# Intel Technical Advisory

TA-1054-01

## Incorrectly wired SATA power cables on the Intel<sup>®</sup> Server System P4000 Family and the Intel<sup>®</sup> Server Chassis P4000 Family

Figure 1. Location of the date code "P/N DD0S6CPB700 12/15/2013"

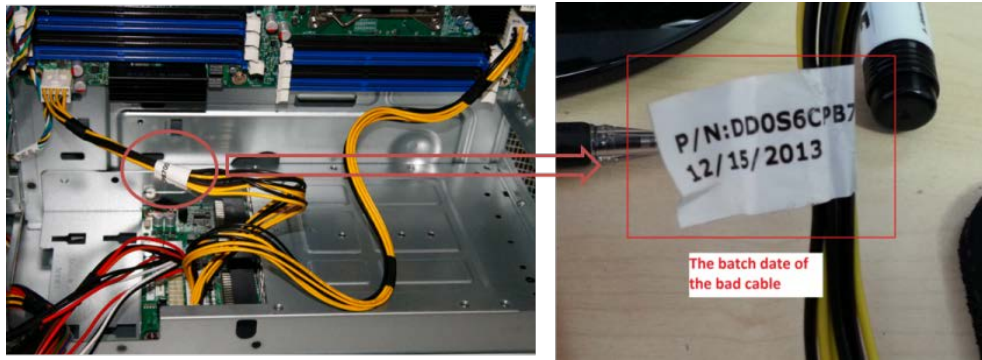
It has been confirmed that the issue happens only with a certain date code "P/N DD0S6CPB700 12/15/2013" of the power cable that connects to the 2x12 pin connector (labeled "Main PWR1") on the PDB. Customers can identify the date code by locating the label shown in Figure 1.

Intel will provide the correct power cable to customers as a replacement upon request. Please contact Intel using your normal warranty process to obtain the cable. Please indicate you are calling regarding TA-1054-01 for a replacement cable with the part number DD0S6CPB700 and have the following information when you call: serial number(s) for the system(s) or chassis.

Figure 3. Pin connection of the two SATA 1x5 pin Peripheral Power Connectors (labeled P5 and P6)

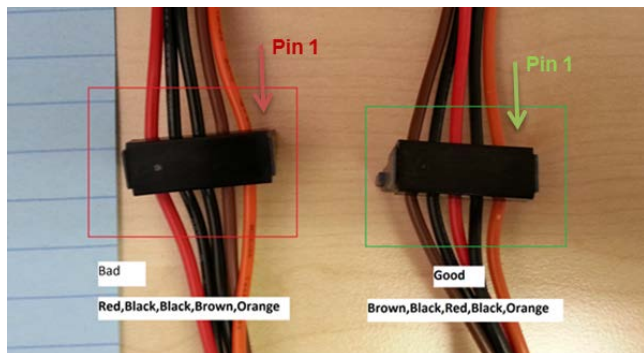
Intel has determined that this failure is due to the incorrectly wired pin connection on the two SATA 1x5 pin Peripheral Power Connectors (labeled P5 and P6). The correct pin definition of the connector should be Orange, Black, Red, Black, and Brown from Pin 1 while the problematic connectors are wired in a different order as Orange, Brown, Black, Black, and Red from Pin 1.

Intel has screened the current inventory to ensure systems and chassis are shipped with the correct SATA power connectors.
